July 29, 2014

**RE: Comments on the Draft Bay Delta Conservation Plan and DEIS/DEIR**

*Comments of Defenders of Wildlife, NRDC, the Bay Institute, and Golden Gate Salmon Association regarding the Draft Bay Delta Conservation Plan and Associated DEIS/DEIR July 29, 2014*

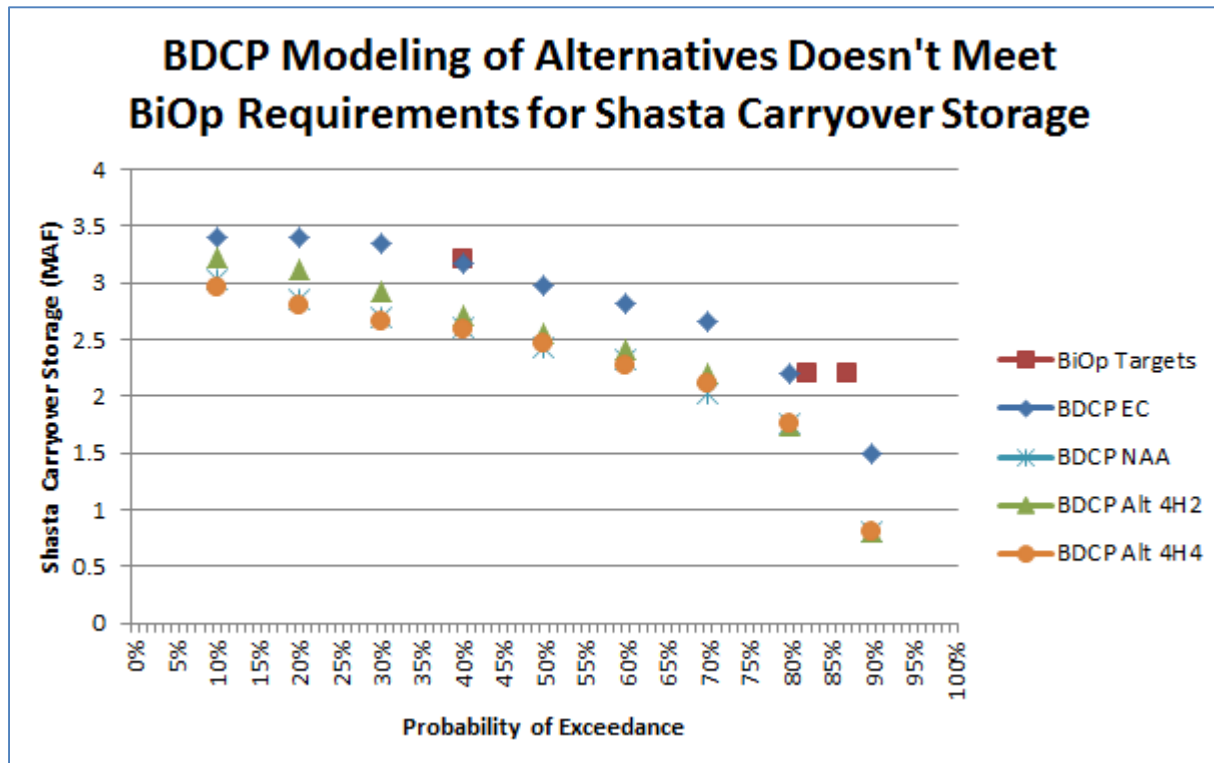
intention" of meeting D-1641 standards. This does not seem to be the case in certain dry years such as 2013 and 2014, and the effects of similar relaxations of water quality standards and other environmental requirements in the future are not analyzed or disclosed in the DEIS/DEIR, despite the fact that such changes are reasonably foreseeable. According to the 2014 independent panel review of delta outflow and other stressors, "The average measured Delta outflow during fall 2013 was approximately 2,000 cfs, which failed to meet the Board's minimum outflow requirement of 3,000 to 3,500 cfs for fall months of a critically dry year." DSP Outflows Review Panel Report 2014 at 15. Likely future waivers and relaxations of standards modeled in BDCP are yet another example of how the modeling of BDCP fails to accurately assess likely environmental impacts.

Second, D-1641 sets limits on south Delta exports based on Delta inflow, known as the export:inflow ratio (E/I ratio), during certain months of the year. The inconsistent application of the allowable E/I ratio to the different alternatives and scenarios, *see* DEIS/DEIR at ES34-ES35, is a long-standing problem with the BDCP modeling. BDCP defines the D-1641-E/I ratio—except in scenarios H2 and H4—to ignore both the inflow to the Delta being exported by the proposed north Delta intakes and those exports, thus exempting the north Delta intakes from compliance with the D-1641 export/inflow requirement. In contrast, the intent of the D-1641 E/I ratio is to limit pumping by the CVP/SWP to a fraction of Delta inflow, regardless of where the CVP/SWP intakes are located. The sensitivity analysis memo (DEIS/DEIR at 5A-D148) characterizes the approach taken in H2 and H4—the NMFS approach—as minimally different from the BDCP approach, and if this is the case, then it is unclear why a single approach was not universally followed for clarity and simplicity. Using an inconsistent E/I ratio introduces complexity, confusion, and obfuscation where there is no need for it, hampering the transparent and concise disclosure of impacts to decision makers and the public.
